# TS-590S ALC circuit modification procedure

The modification takes approximately 1.5 hours to complete in service centers. The TS-590S uses lead-free solder and multi-layer PCBs, so it should not be carried out by owners / end users.

Serial number range : B09xxxxx to B3Cxxxxx. (From S/No.B4100001 the modification has been applied.)

**FINAL UNIT (X45-391x-xx, X45-398x-xx) Component side view**

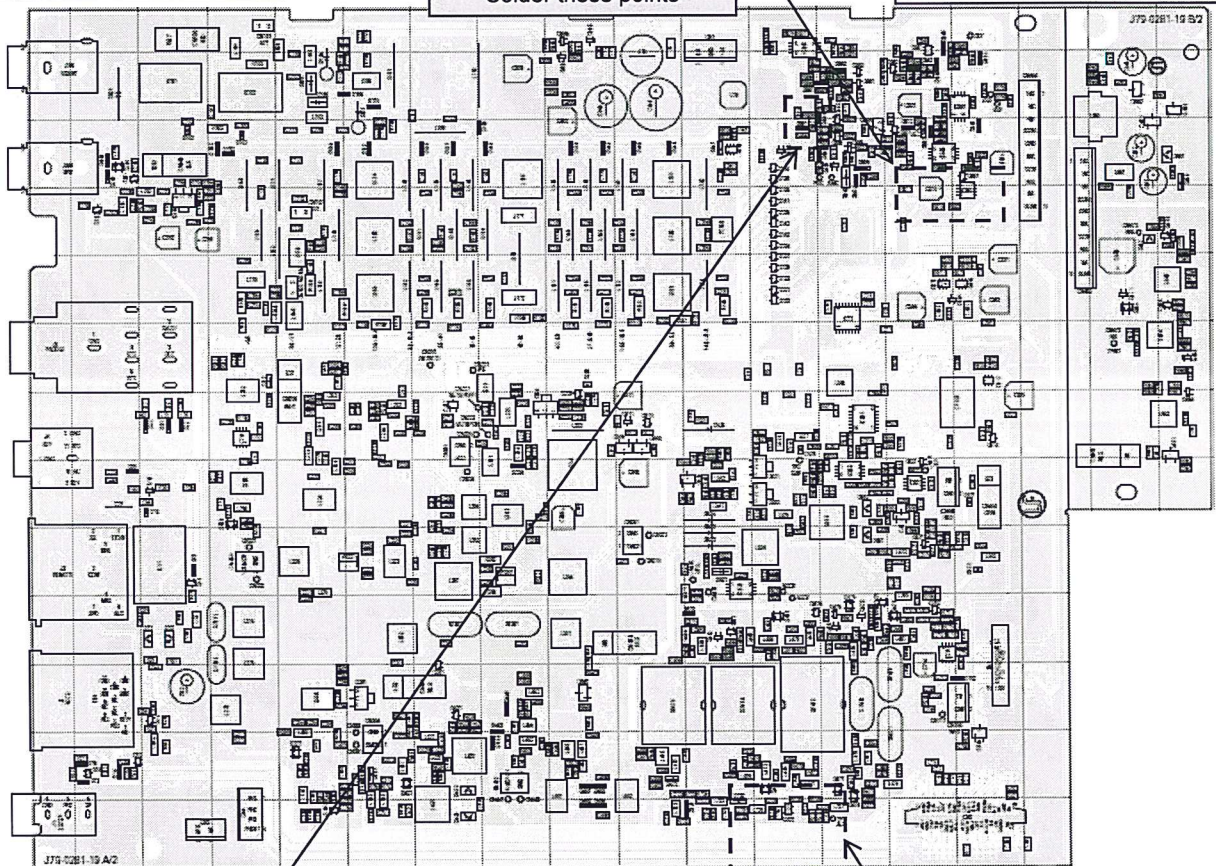
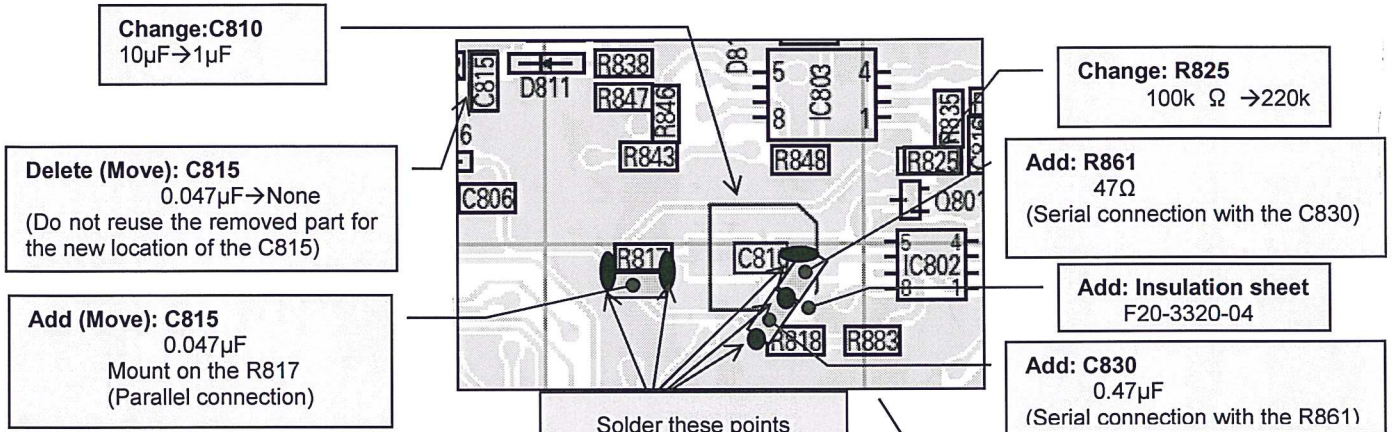
Ref No.	Status	OLD Part No.	NEW Part No.	Remarks
L255	Change	L33-0695-05	LR79Q0CW222J	1mH → 2.2mH
R20	Change	RS14DB3A470J	RS14DB3A151J	47Ω → 150Ω
R21	Change	RS14DB3A470J	RS14DB3A151J	47Ω → 150Ω
C78→R24	Change	CC73FCH1H470J	RK73FB2B102J	47pF → 1kΩ
R25	Change	RK73FB2B472J	RK73FB2B223J	4.7kΩ → 22kΩ
R26	Change	RK73FB2B472J	RK73FB2B223J	4.7kΩ → 22kΩ
C79→R35	Change	CC73FCH1H470J	RK73FB2B102J	47pF → 1kΩ
R60	Add	-----	RK73GB2A562J	Parallel connection with C51
R61	Add	-----	RK73GB2A562J	Parallel connection with C57
R270	Change	RK73FB2B103J	RK73FB2B000J	10kΩ → 0Ω

\*In the service manual, 2 x RK73FB2B471J (470Ω) resistors are listed at the location of R24, R35 instead of the actually mounted C78, C79 (47pF). Please replace these capacitors with 1kΩ resistors.

TX-RX UNIT (X57-785x-xx, X57-861x-xx) Component side view

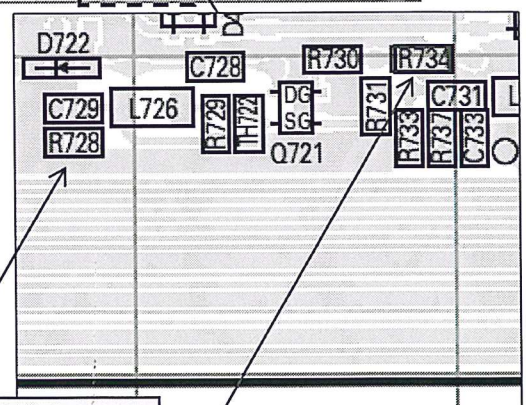
Ref No.	Status	OLD Part No.	NEW Part No.	Remarks
-----	Add	-----	F20-3320-04	Insulation sheet (2mm x 3mm x 0.05mm)
C810	Change	CE32CL1C100M	CK73FB1C105K	10μF → 1μF
C815	Delete(Move)	CK73GB1H473K	-----	0.047μF → Delete
C815	Add(Move)	-----	CK73GB1H473K	Parallel connection with R817
C830	Add	-----	CK73GB1C474K	Serial connection with R861
D801	Change	EDZ5.1B	EDZV6.2B	5.1V → 6.2V
R728	Change	RK73GB2A331J	RK73GB2A101J	330Ω → 100Ω
R734	Change	RK73GB2A223J	RK73GB2A102J	22kΩ → 1kΩ
R807	Change	RK73GB2A472J	RK73GB2A332J	4.7kΩ → 3.3kΩ
R809	Change	RK73GB2A182J	RK73GB2A222J	1.8kΩ → 2.2kΩ
R825	Change	RK73GB2A104J	RK73GB2A224J	100kΩ → 220kΩ
R861	Add	-----	RK73GB2A470J	Serial connection with C830

- Change: R809**  
1.8k $\Omega$   $\rightarrow$  2.2k $\Omega$
- Change: R807**  
4.7k $\Omega$   $\rightarrow$  3.3k $\Omega$
- Change: D801**  
5.1V  $\rightarrow$  6.2V
- Change: R728**  
330 $\Omega$   $\rightarrow$  100 $\Omega$

- Change: R734**  
22k $\Omega$   $\rightarrow$  1k $\Omega$

**FINAL UNIT (X45-391x-xx, X45-398x-xx) Schematic diagram**

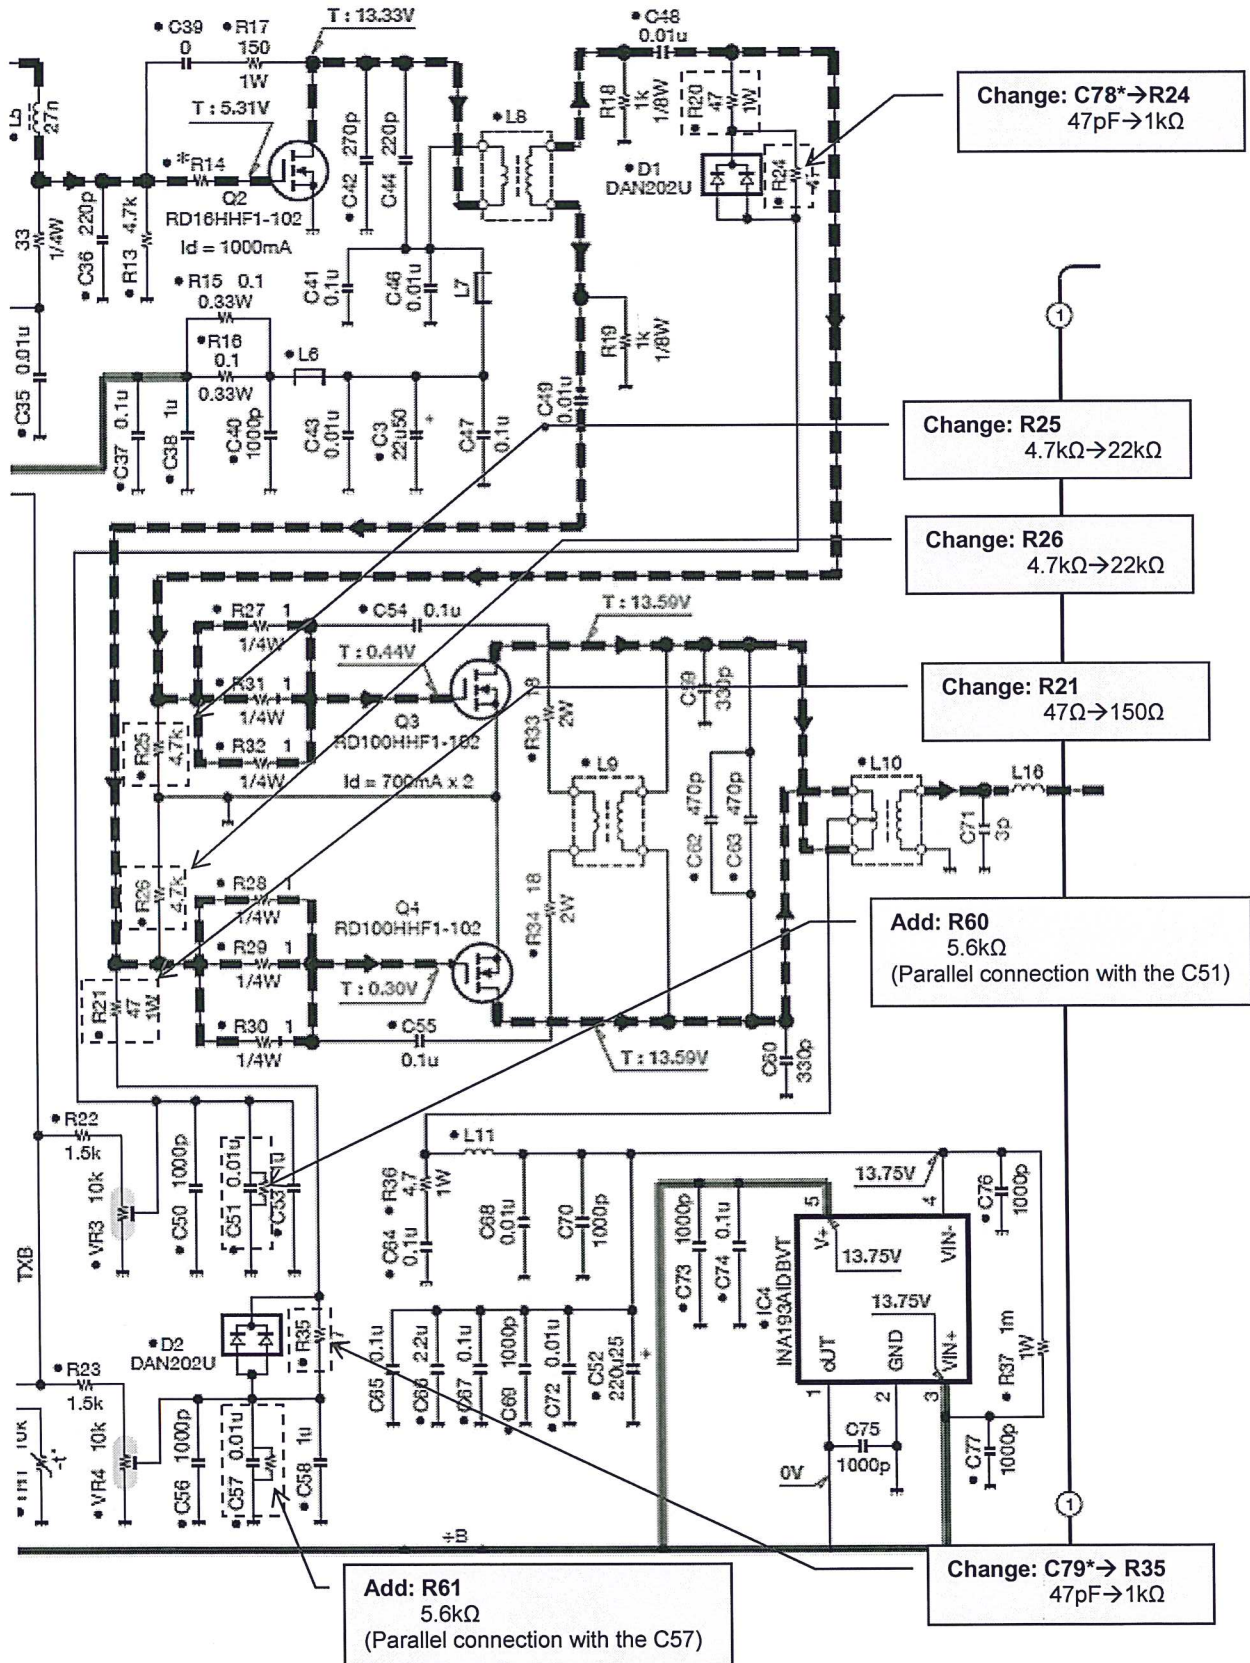
\*In the service manual, 2 x 470Ω (RK73FB2B471J) resistors are listed at the location of R24, R35 instead of the actually mounted C78, C79 (47pF). Please replace these capacitors with 1kΩ resistors.
